SERVICE BULLETIN

No. 202

Piper Aircraft Corporation

SUBJECT: Inspection of Comanche Exhaust System
MODELS AFFECTED: PA-24 "250" Comanches - Serial Nos. 24-103 to 24-1629 inclusive
DATE OF COMPLIANCE: Prior to but not later than next 100 hour inspection

SKETCH "A"

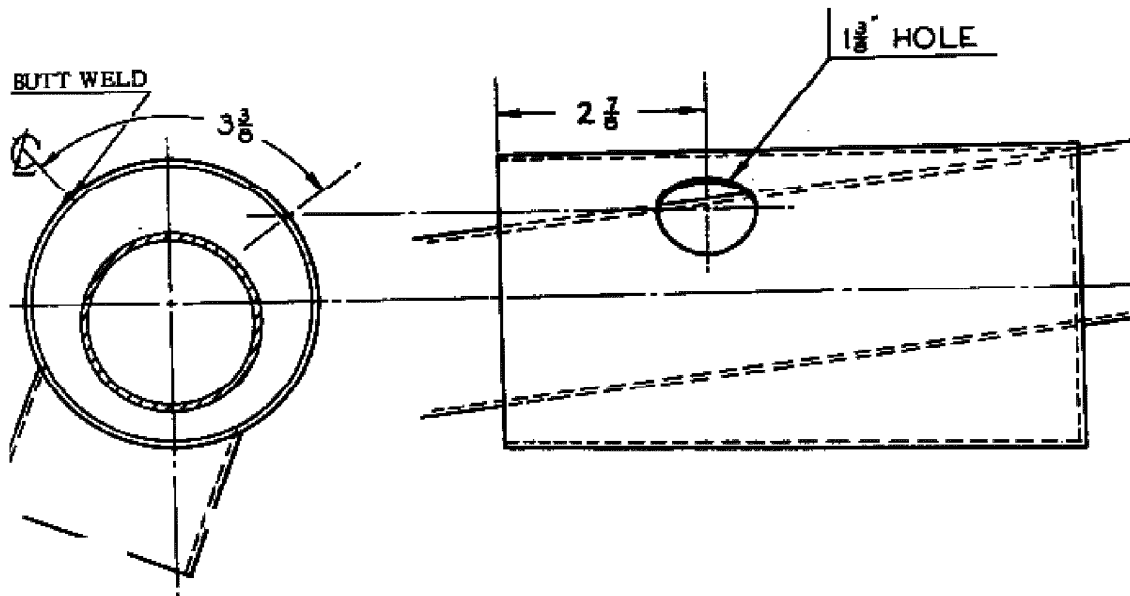
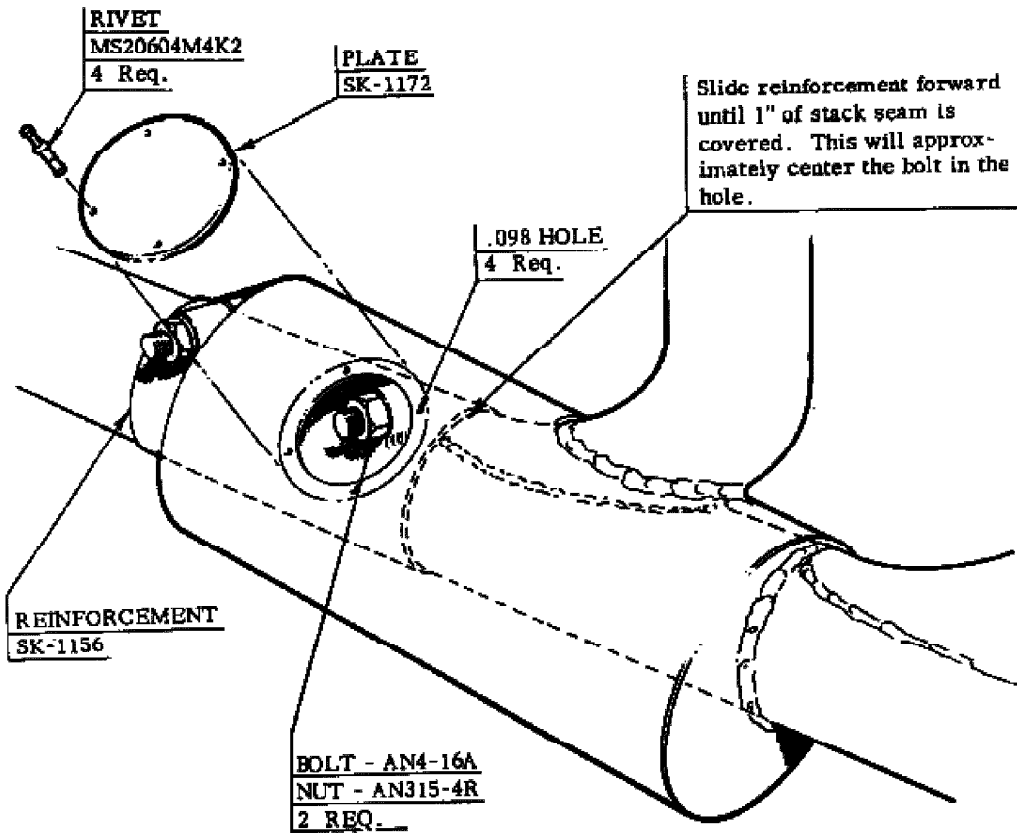
Field service reports indicate that cracks have been appearing in the engine exhaust stack assembly, right side - Part Number 21664-03. It is requested these stacks be inspected for cracks or other indications of deterioration in the following manner:

1. Remove or loosen the shroud assembly.
2. Inspect the exhaust stack assembly for any indication of cracks or deterioration. A thorough examination of the area where the rear cylinder exhaust stack is welded to the exhaust stack assembly should be made. This assembly must be replaced immediately if this condition is noted.
3. Exhaust stacks that have the reinforcement plate welded to the stack in the area where Kit No. 754 396 is to be installed will not be affected by this Bulletin.
4. Stacks that do not have the reinforcement plate but are found to be in satisfactory condition shall be inspected each 50 hours of operation until reinforced with Kit No. 754 396. Installation of Kit No. 754 396 must be accomplished prior to but not later than the next 100 hour inspection. Refer to sketch below and instruction sheet.

1. Disconnect at the shroud, air ducts running from carburetor heat air shroud to engine baffle and carburetor heat air intake.
2. Remove screws and nuts from carburetor heat shroud in order to gain accessibility to exhaust stack.

3. Locate, mark and drill holes in stationary part of air shroud as per Sketch "A".
4. Make sure all metal filings are cleaned out of shroud before reassembly of air shroud

5. Install reinforcement on exhaust stack. Slide reinforcement forward until bolt is centered in hole cut in air shroud. This should move the reinforcement far enough forward to cover 1" of exhaust stack weld.

6. Torque nuts to 120 inch lbs. on the initial installation of the reinforcement. Run up the engine on the ground at 1500 RPM for five minutes. After ground run up torque nuts to 60 inch lbs.

7. Reassemble shroud, hook up air ducts and make another ground run up for five minutes at 1500 RPM. Again check nut torque value for 60 inch lbs. This procedure allows the reinforcement to seat on the stack assembly Stake bolt threads to safety nuts

8. After final torque check install repair plate Part No. SK-1172 as per Sketch "A".
